PENNSYLVANIA ELECTRIC COMPANY
THREE MILE ISLAND NUCLEAR STATION UNIT 1

Operating License No. DPR-50
Docket No. 50-289
Technical Specification Change Request No. 80

Technical Specification Change Request No. 80

Figure 2.3-2

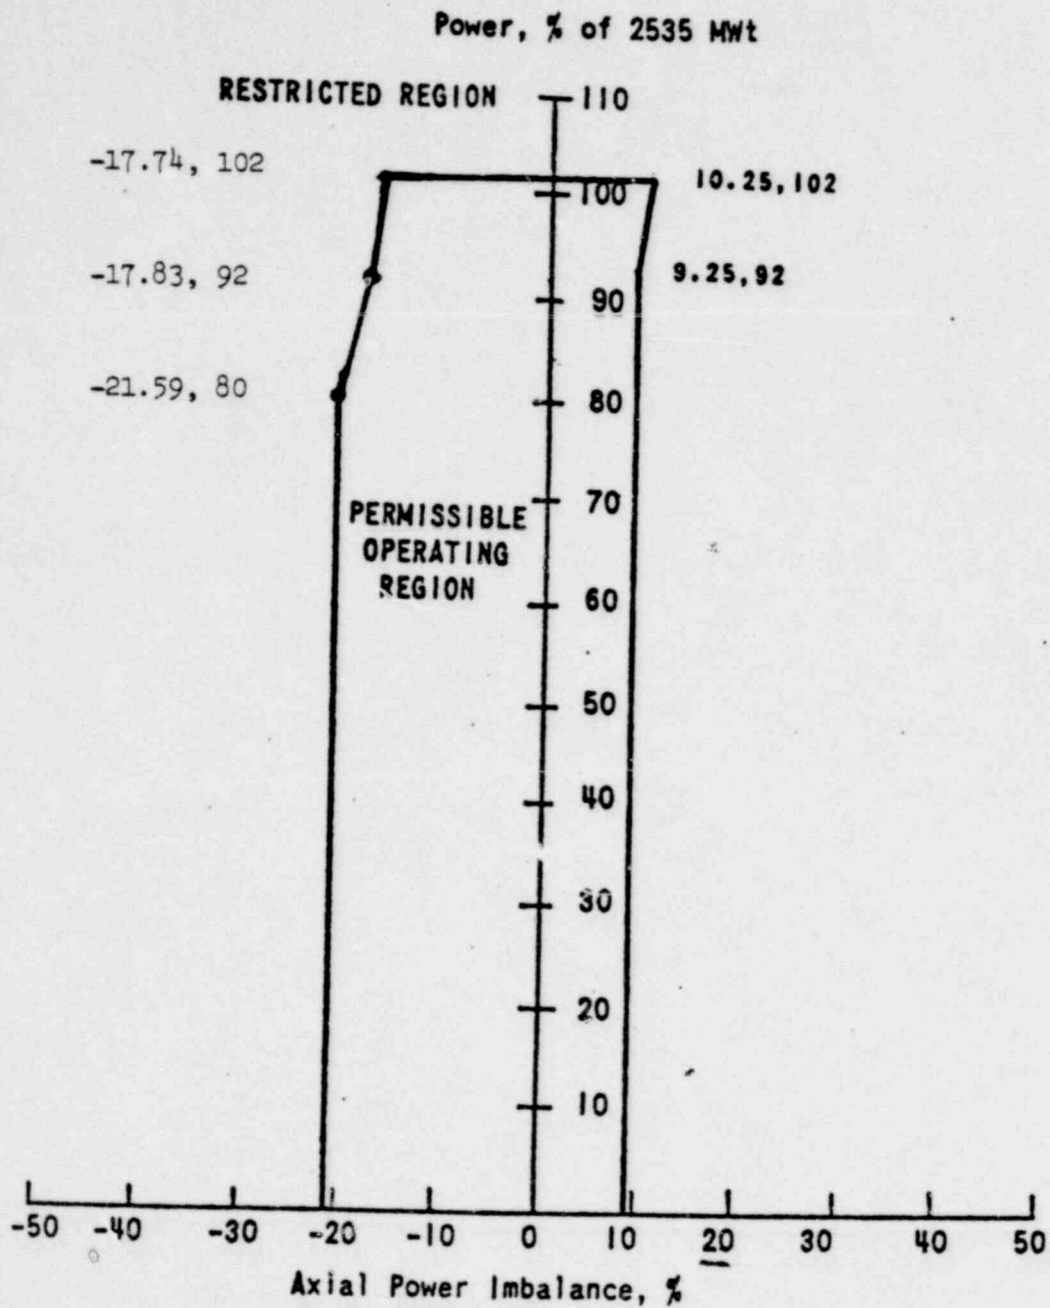
Figure 2.3-2 was changed to reduce the negative reactor power imbalance from -17% to -12% at breakpoint B₂, without changing the slopes between breakpoints. This adjustment is conservative since the core was Central Fuel Melt (CFM) limited for the RPS, and the total peak which sets CFM limits, had a measured to calculated discrepancy less than 4% above the acceptance criterion.

Figure 3.5-2E

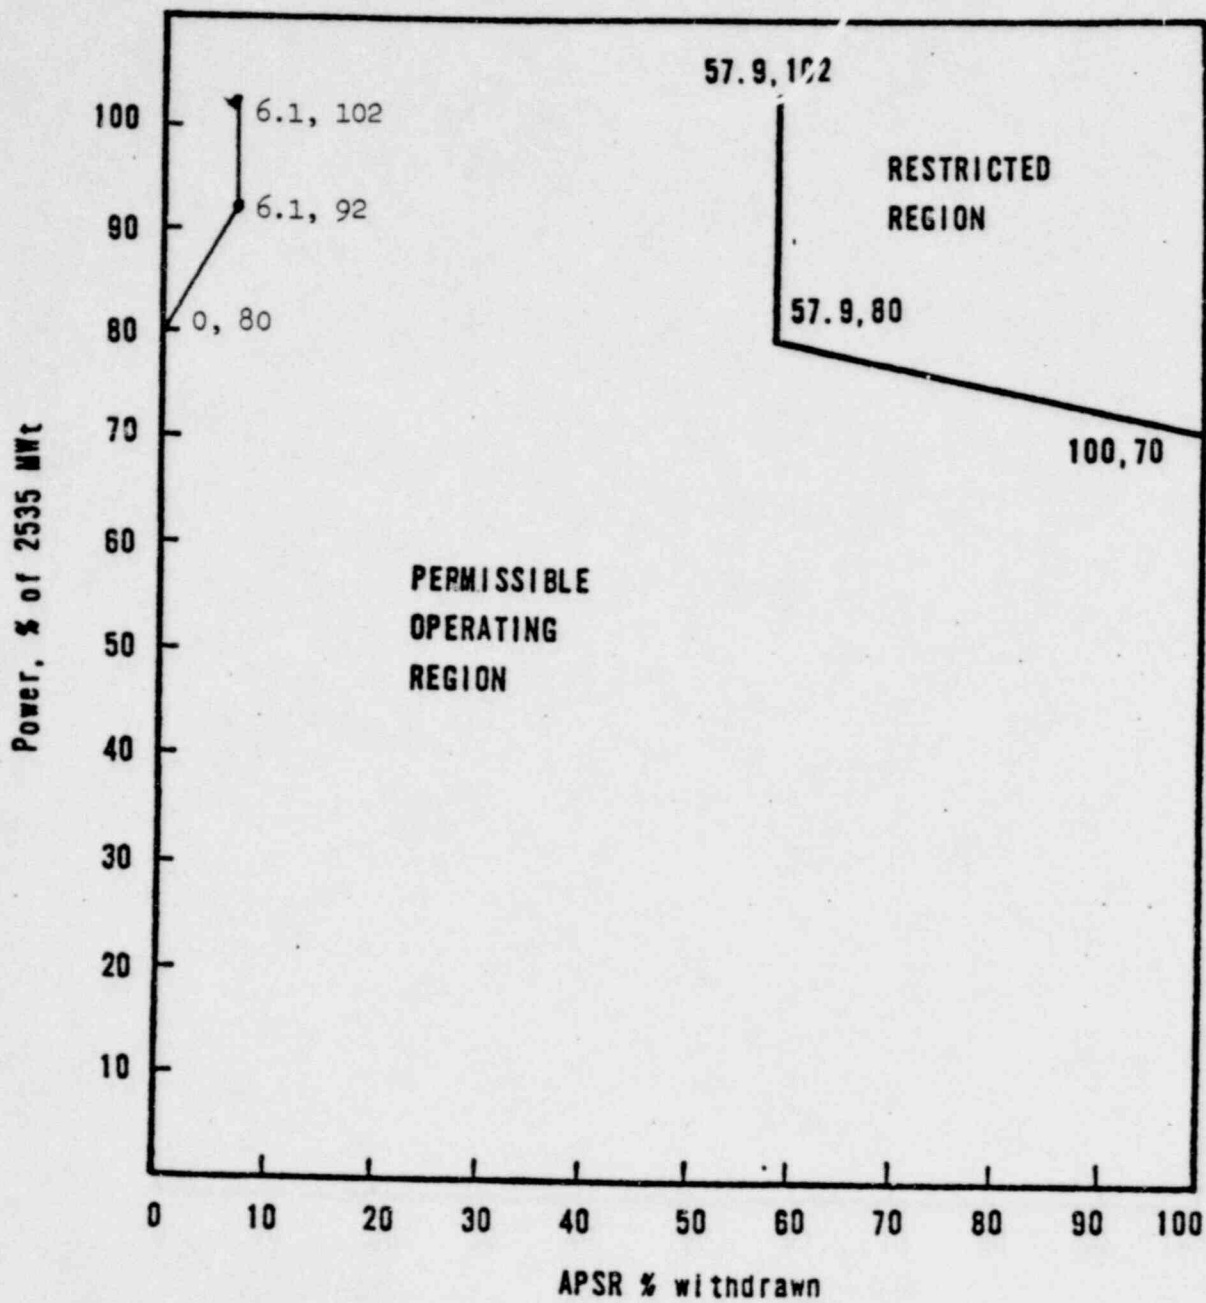
Figure 3.5-2E was changed to reduce the negative axial power imbalance from -23.40% to -17.74% at the 102% FP breakpoint, and from -21.59% to 17.83% at the 92% FP breakpoint.

The adjustments to Figure 3.5-2E and Figure 3.5-2H are also conservative since these limits are based on LOCA KW/ft criteria and are not set from predicted total peaks.
